Solicitation Solicitation Amendment

1. Amendment Number A02 to Solicitation Number 360070-22-A-0023		Date 08/18/2022		
2a. Facility DAVENPORT, FL - MAIN OFFICE		2b. Project E54635 Building and Parking Expansion		
3a. Offeror Name and Address		3b. Issued By EASTERN FCCMT 7029 ALBERT PICK RD GREENSBORO, NC 27409-9521		
		3c. Contact NIKHIL SONI Nikhil.Soni@usps.gov

5. Description of Amendment: Amendment A02 serves to provide the following: - Extend the proposal due date to August 31, 2022 at 3:00 PM Eastern Time. - Respond to supplier questions. All other terms and conditions remain the same.

PARTIAL SITE PLAN - AREA "B"
 SCALE: 1/16" = 1'-0"

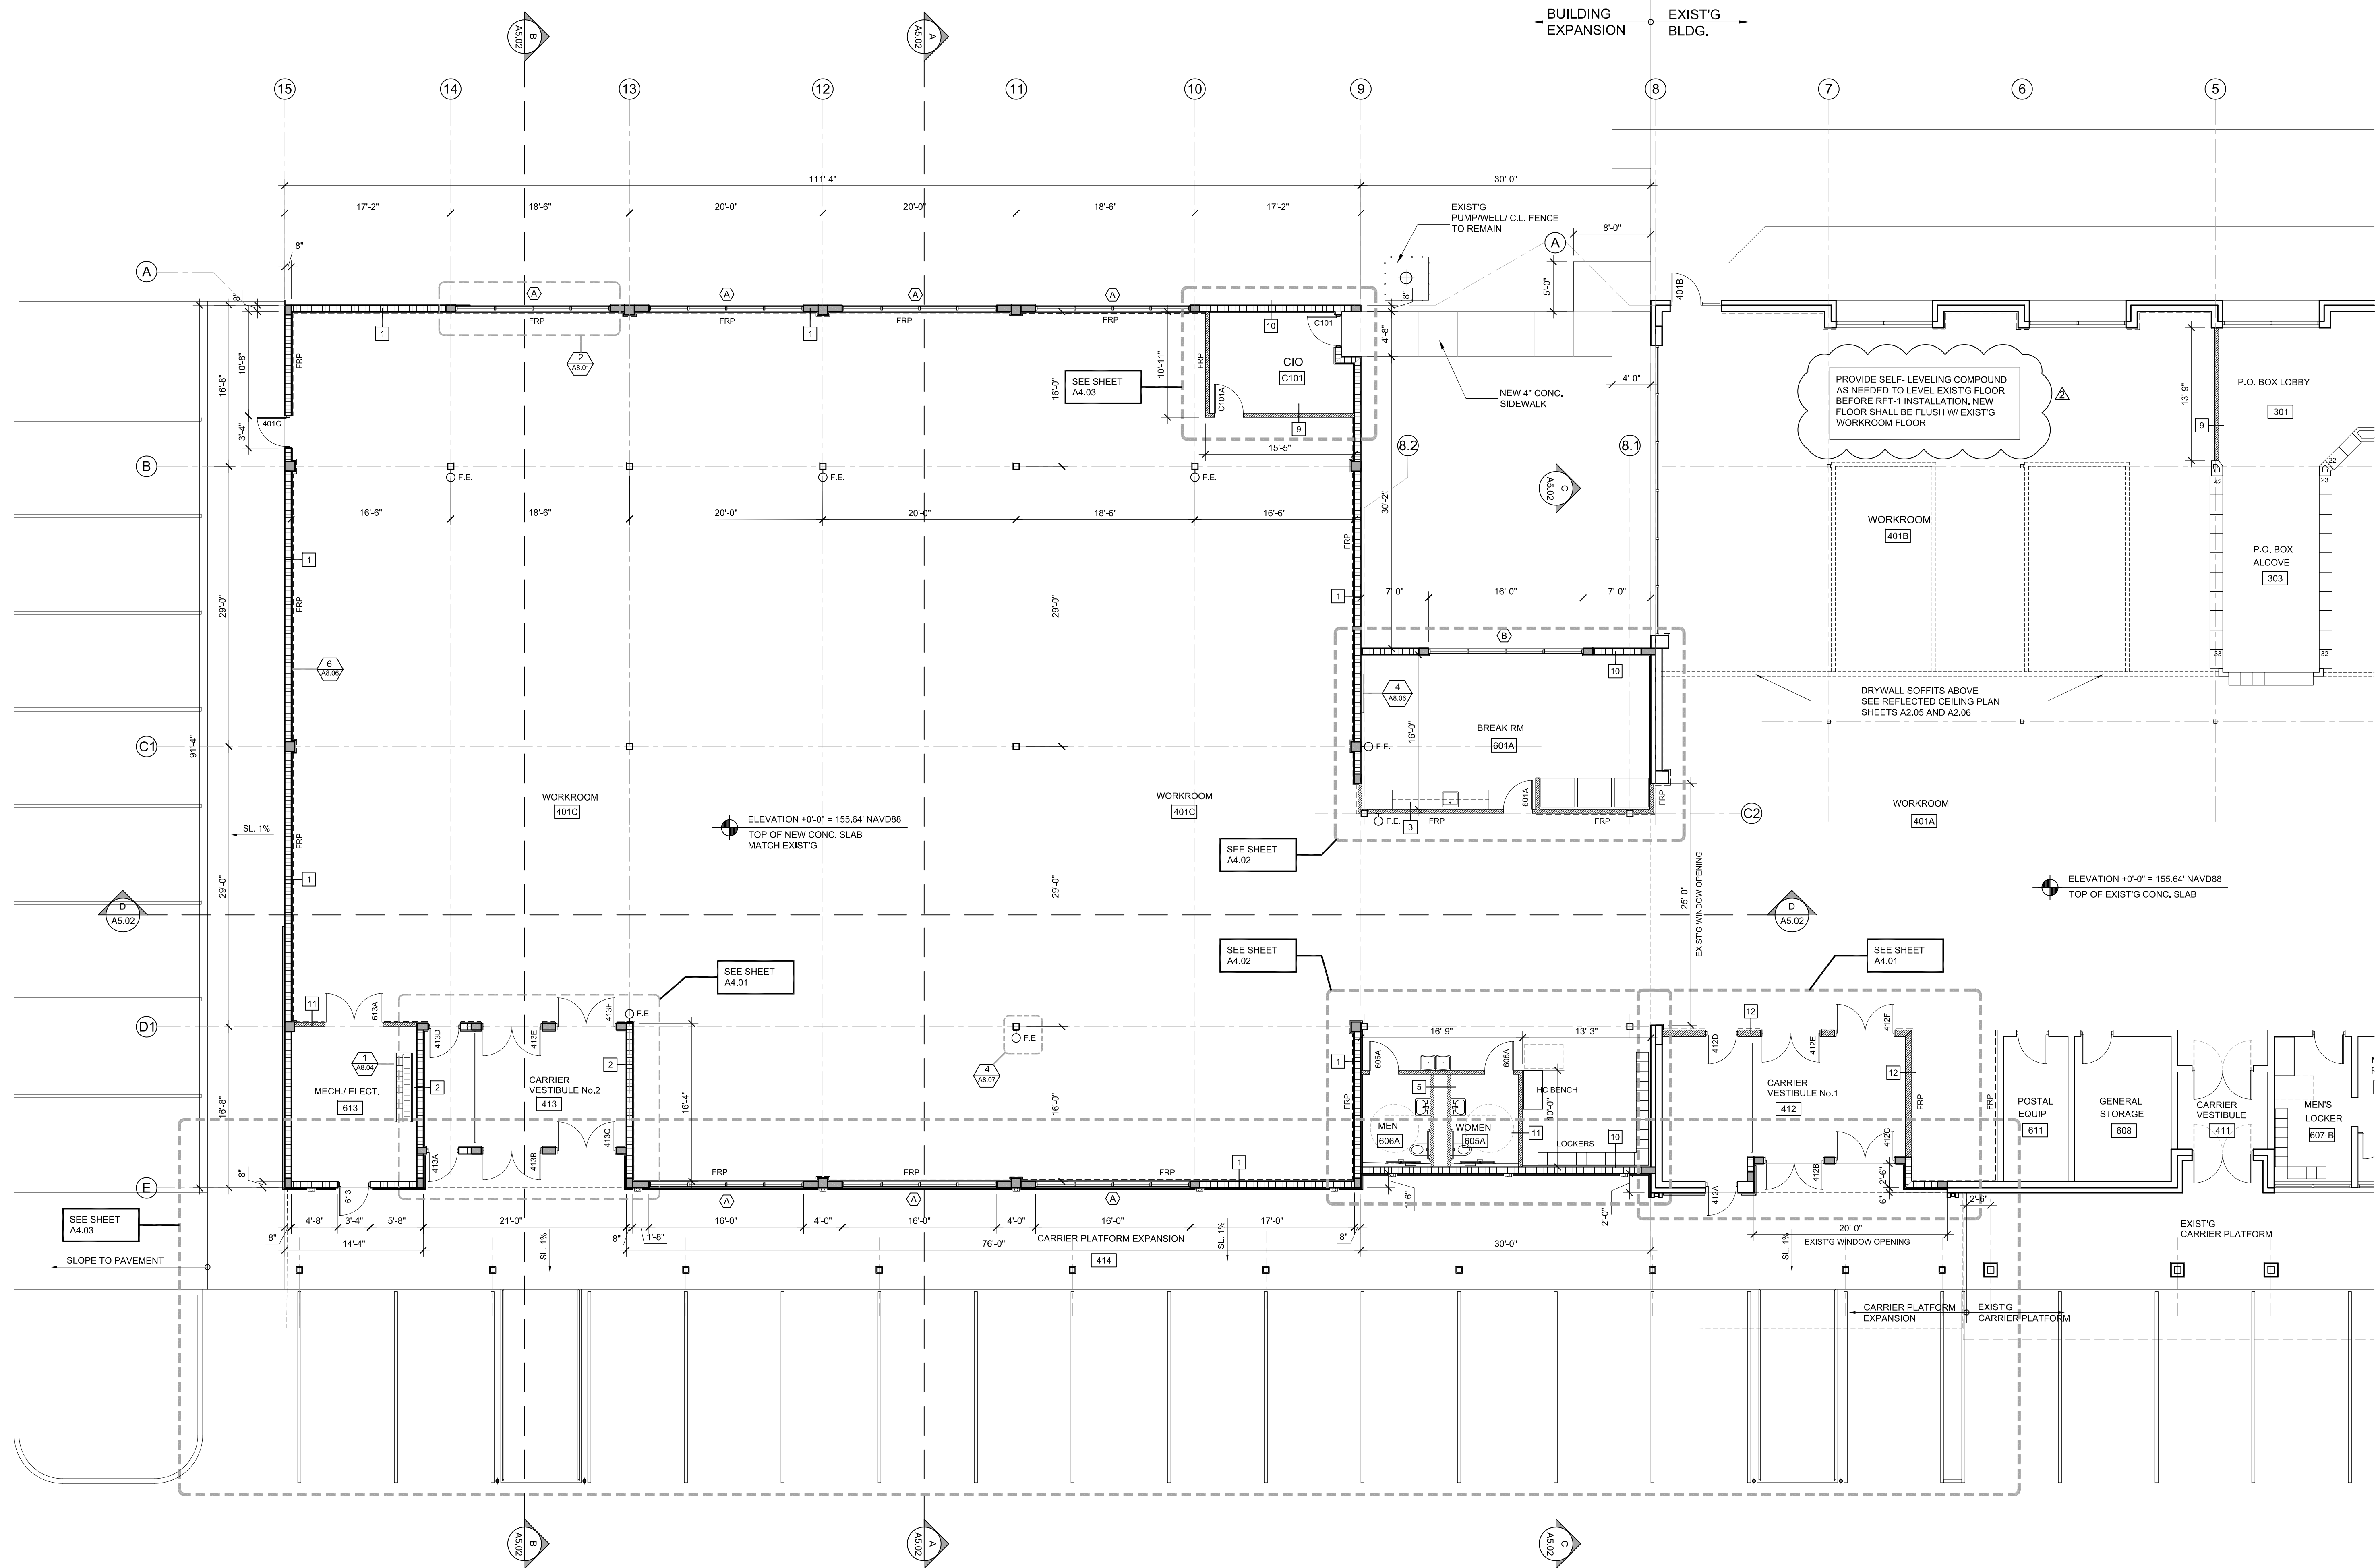
Question: Specific location of each signage

Response: There is no Building Signage in the SOW. Only Interior Signage as shown on A8.07 and Traffic Signage as indicated in Revised Dwg. A1.04 attached

A2.02
 Scale: NOTED
 Date: 08/16/22
 Project: 21-23
 USPS File Number: E54635

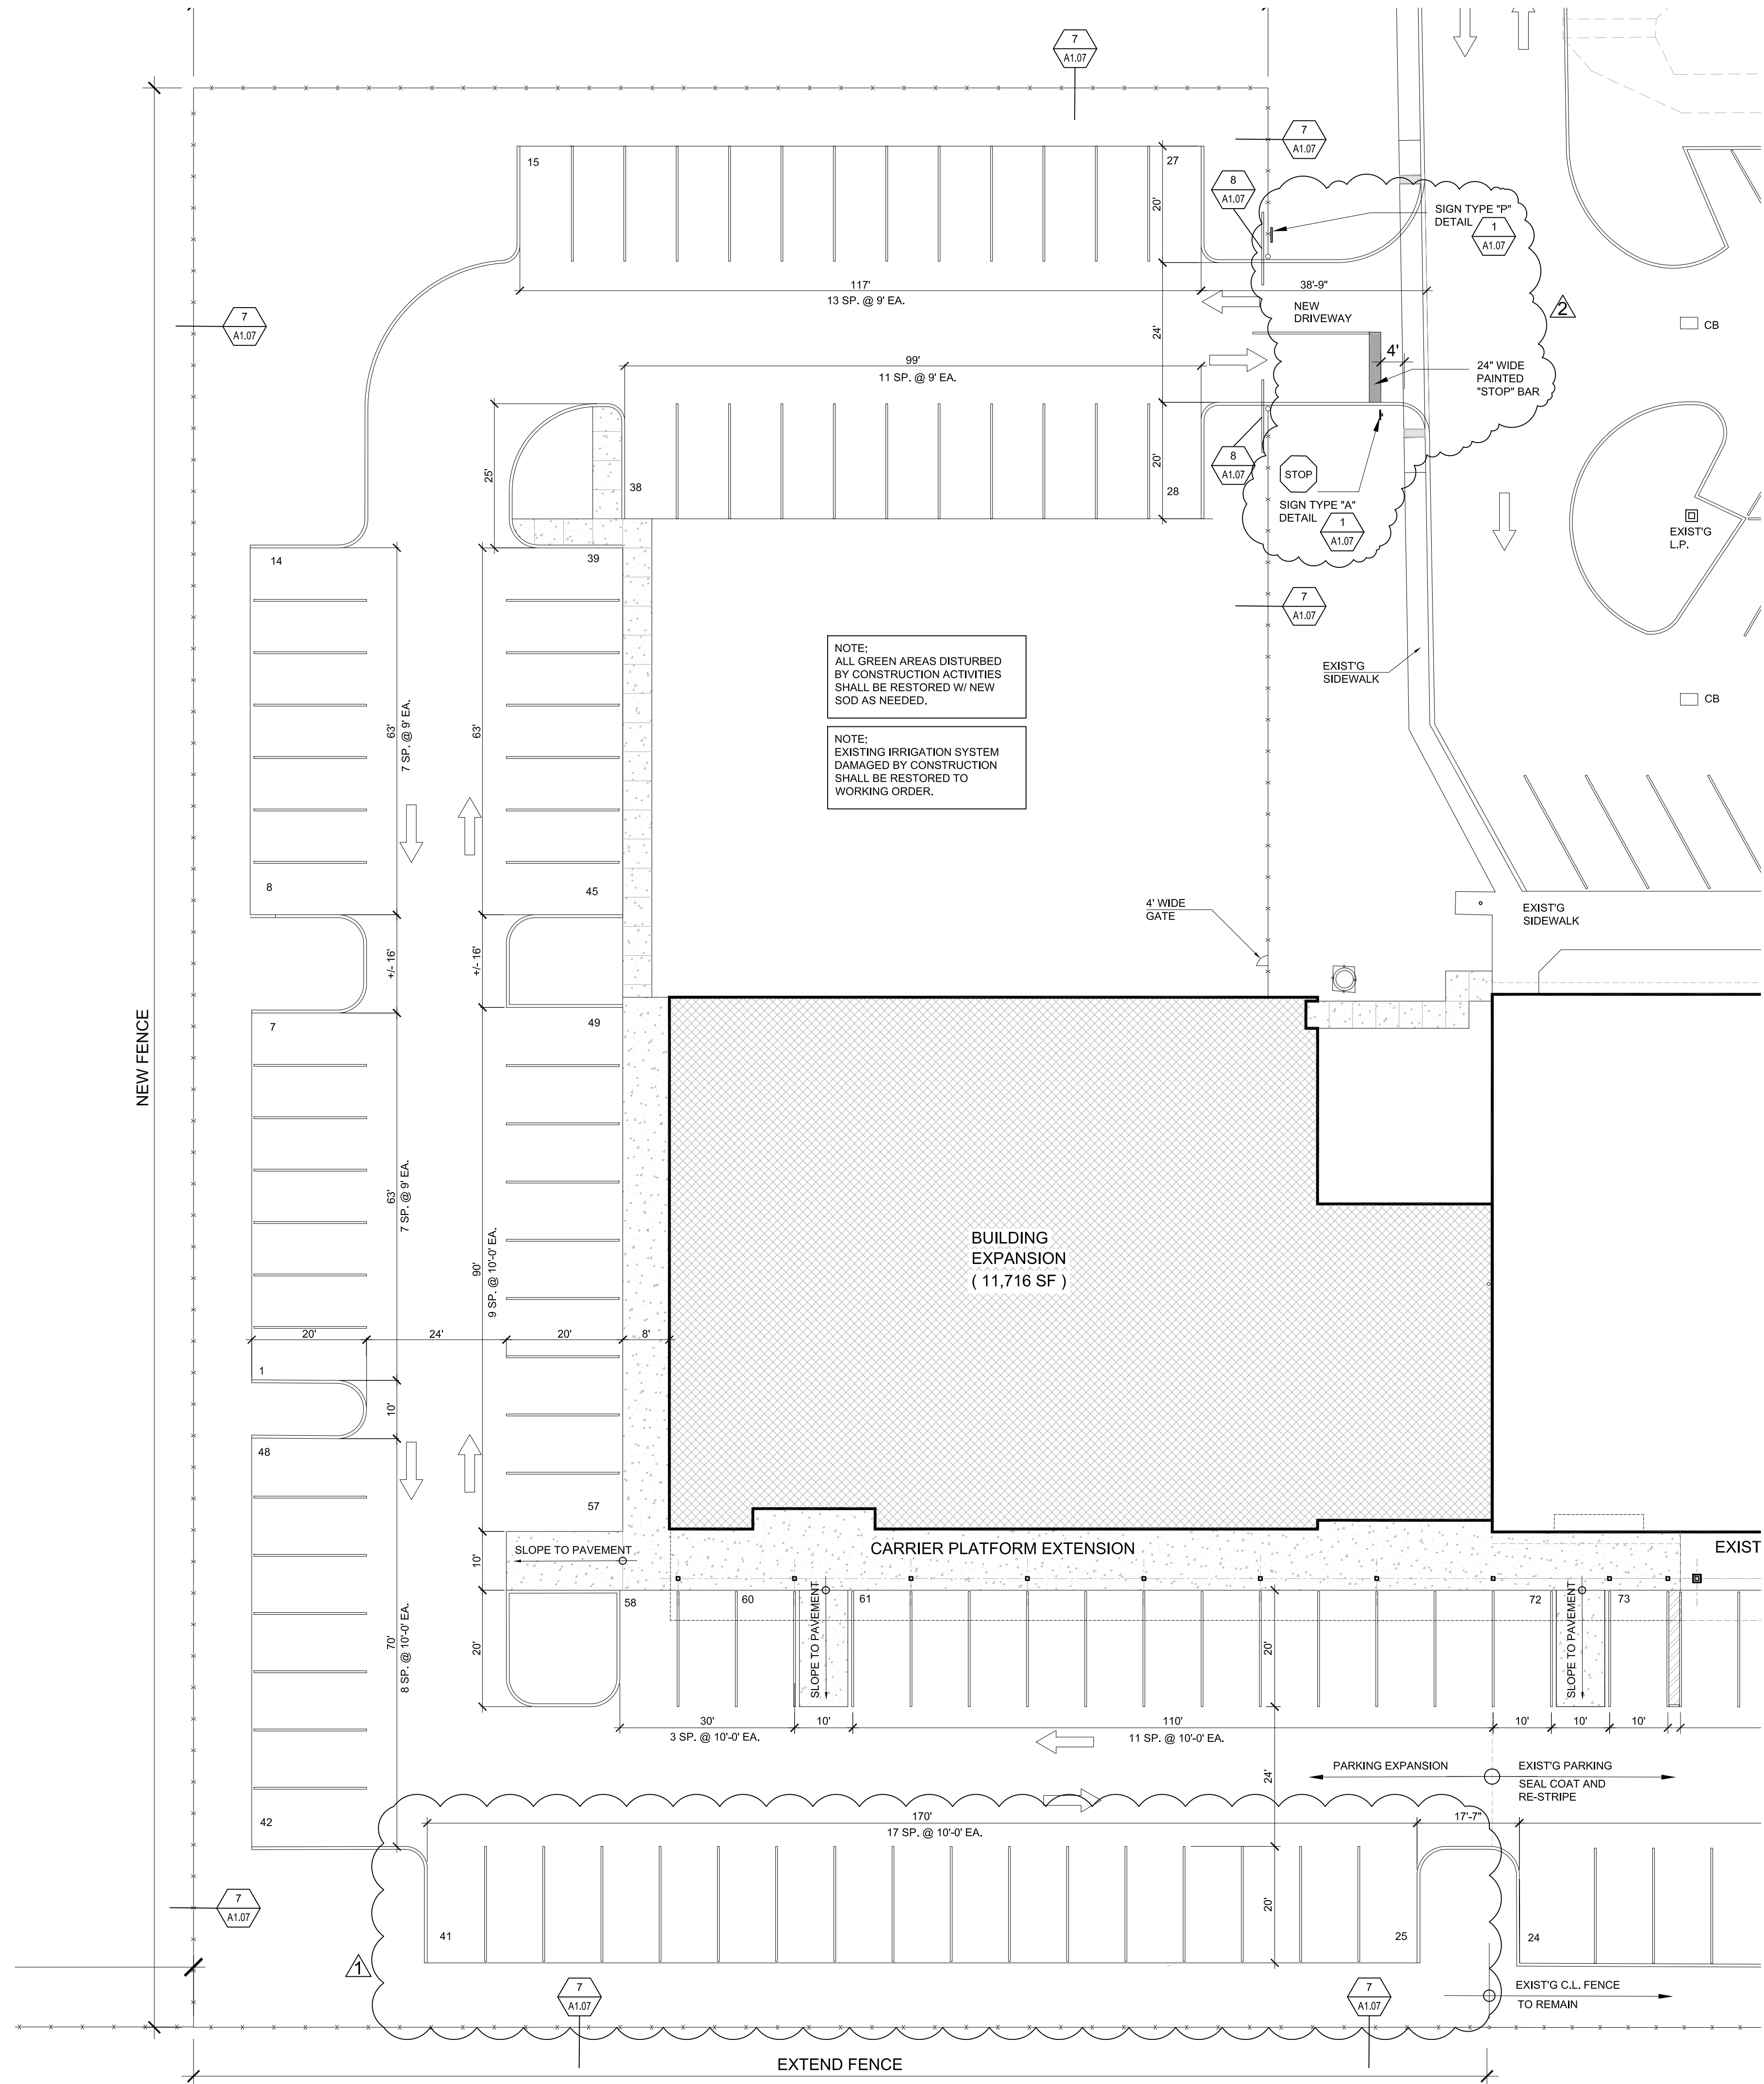
Question: Please send a revised code for Resilient Floor Tiles.

Response: Revised A0.01 & A2.02 provided – See Detail 1/A0.01 “USPS STANDARD COLOR MATERIAL LIST” Any VCT designation is to be interpreted to mean RFT-1
